25 August 2014

Objections to The University of Sydney's Response to Submissions June 2014 in regard to Campus Improvement Program 2014-2020 (CIP), State Significant Development Application (SSD 13_6123)

I write on behalf of Sydney Local Health District (SLHD), the owner and operator of Royal Prince Alfred Hospital (RPAH), the direct neighbour on The University of Sydney's (UOS) western boundary, and therefore also on behalf of the NSW Ministry of Health/Health Administration Corporation.

Sketch 1: Marked-up Section SSD-E-13 RevA – more relevant height and splayed envelope

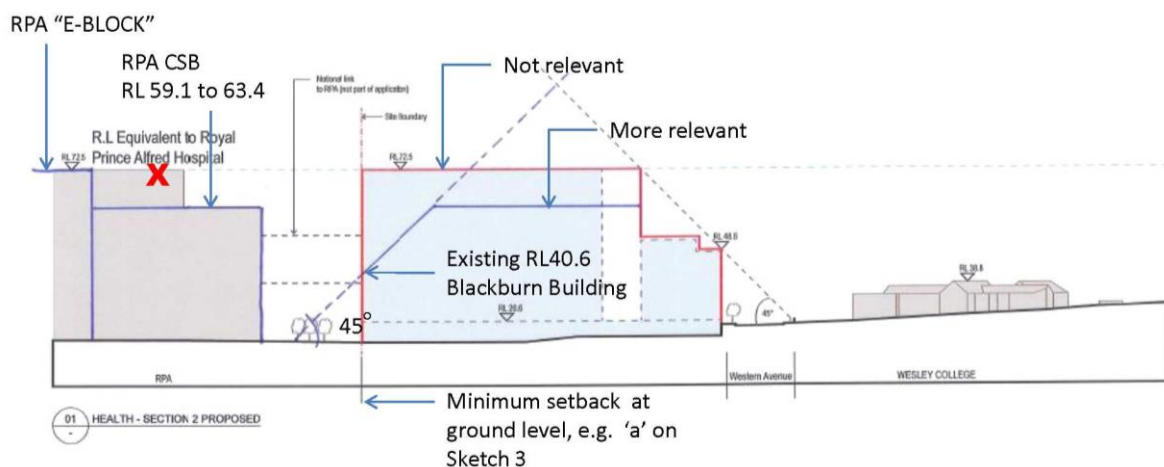
Further, the section on UOS Drawing SSD-E-12 RevA shows RPA's equivalent/ determining height as RL 72.5 from south to north, which is misleading because the RPA CSB is actually RL 50.6 at the northern end, based on the UOS survey. Also, the section on Drawing SSD-E-13 RevA is also ambiguous because it implies an adjacent RPA building of RL72.5 rather than an actual RL 63.4.

The top of the CIP HP envelope should reflect the existing CSB and Gloucester House levels, or the recently approved Charles Perkins Centre, rather than E-Block which is out of context.

Please refer to marked-up sketches 1 and 2 below as an indication of what SLHD would be prepared to discuss with UOS and DPE if an integrated development is not planned together.

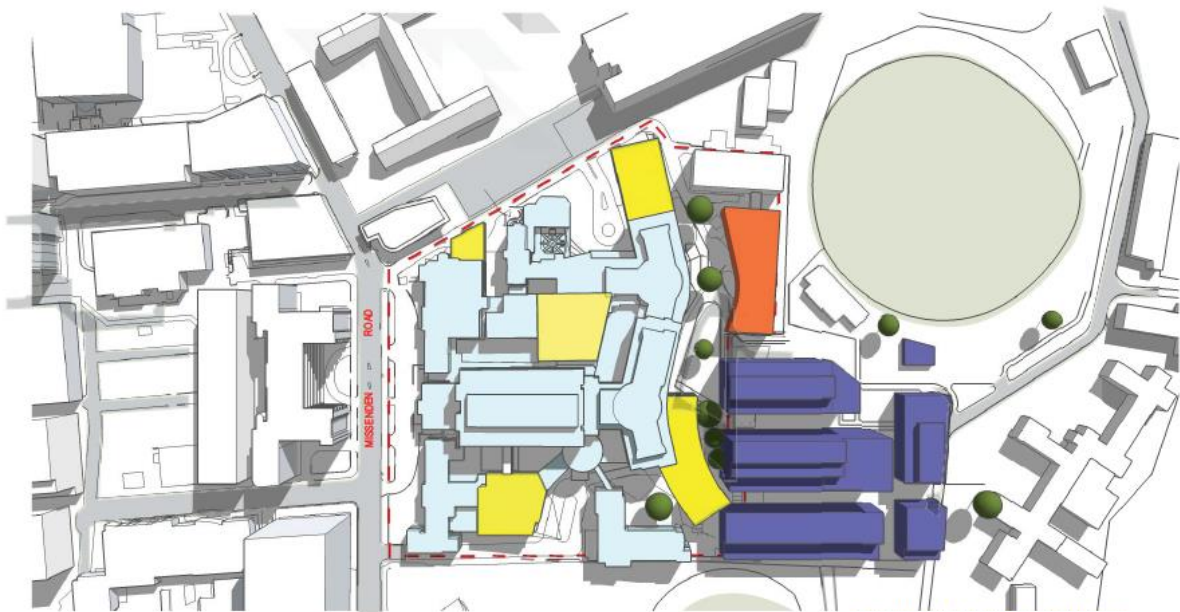
As UOS is aware from preliminary plans discussed in 2013 and 2014 (before and since lodgement of the SSD application), RPA has a growing demand for services that requires extension of the existing CSB on the east campus, adjacent to the boundary with UOS. The two figures below, drawing on RPA's concepts in 2013 and based on the height in the original SSD application (but which has only been marginally reduced in the RtS), demonstrates the conflict between UOS's proposed envelope and RPA's concept plan.

Sketch 3:

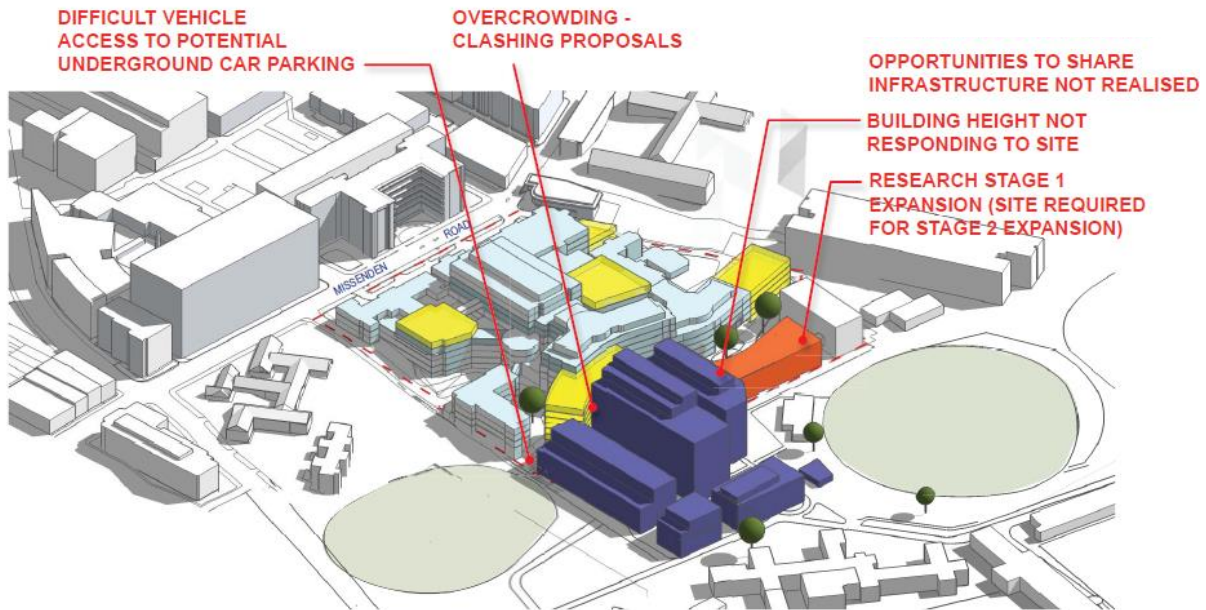
Sketch 3 below highlights the need for minimum setbacks to protect RPA's proposed public inpatient ward block extension.
